Certificate of Appropriateness Request:

H-04-20

94 Union Street, N.

Kristen Boyd-Sullivan, Sr. Planner

TREE 1

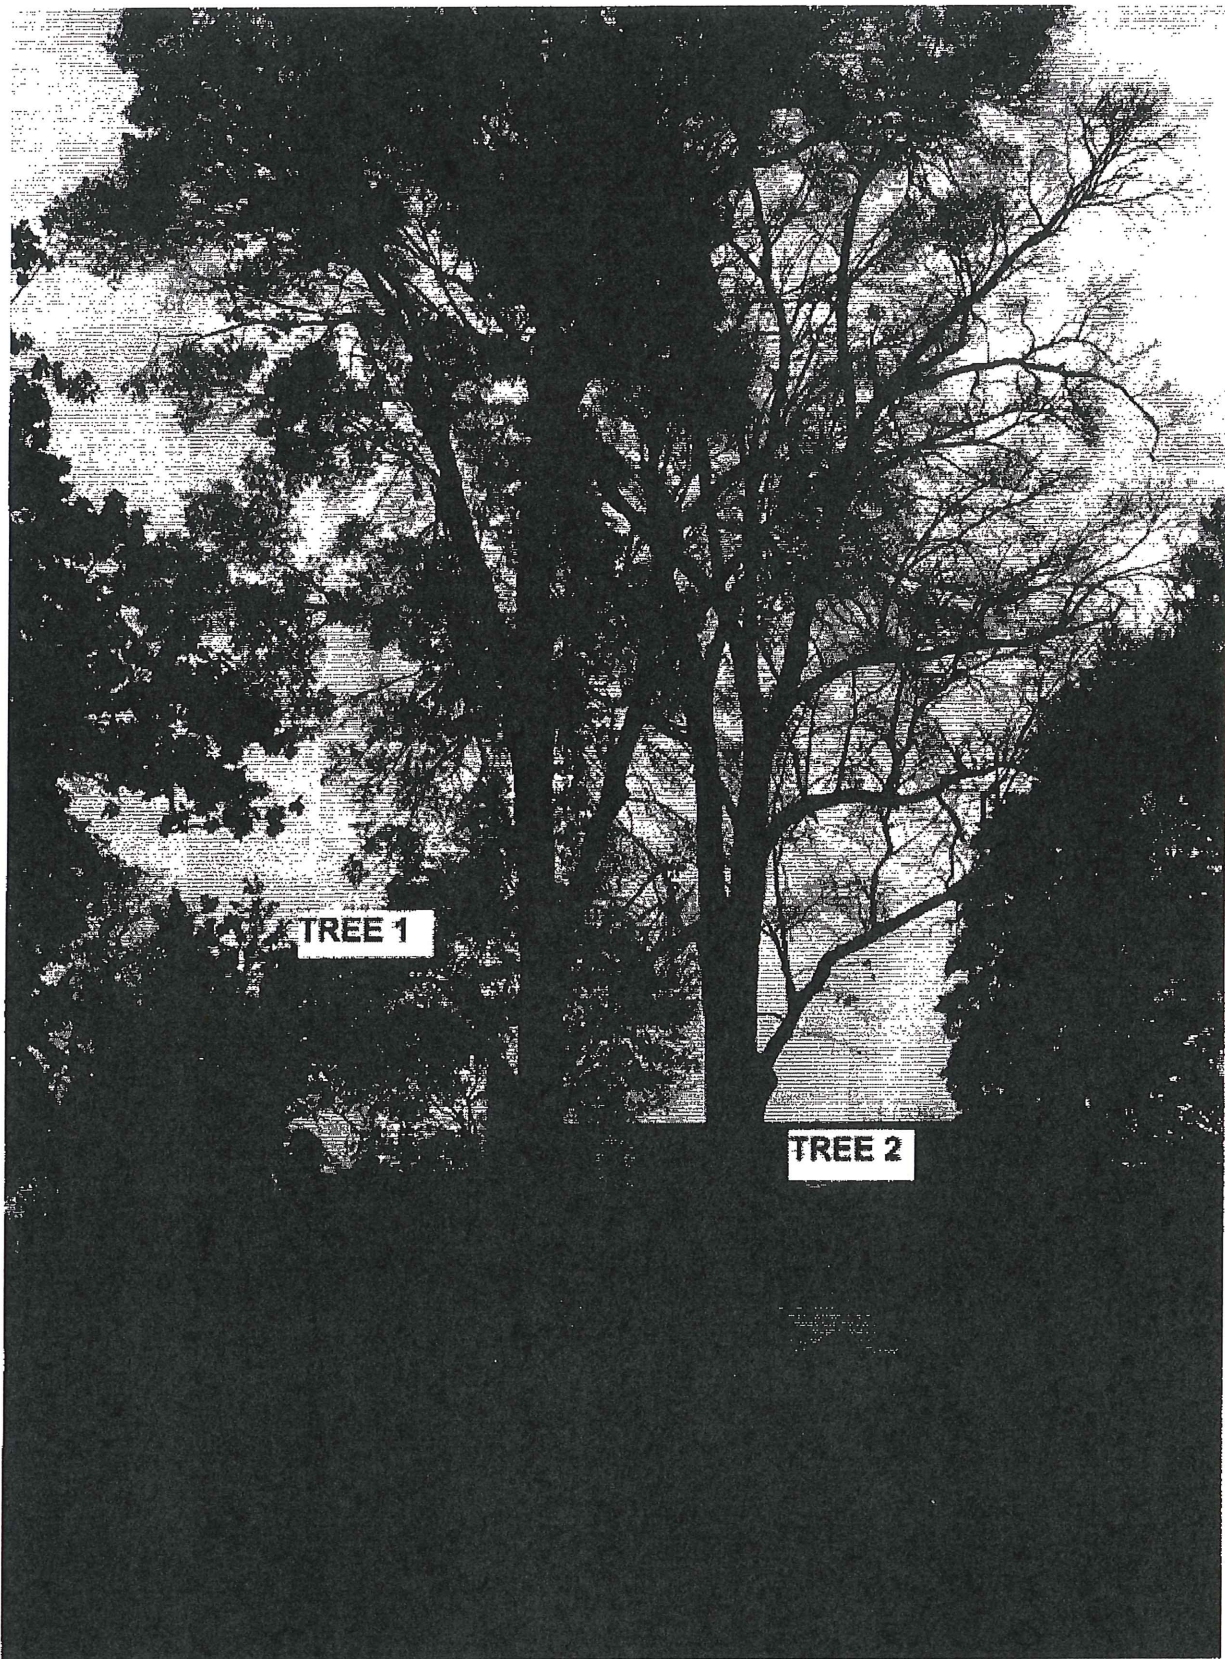
This tree has root decay affecting one quarter of the root crown and considerable trunk lean that is not supported due to this decay. I recommend the removal and replacement of this tree.

My re-assessment of this tree has determined that the above statement remains true.
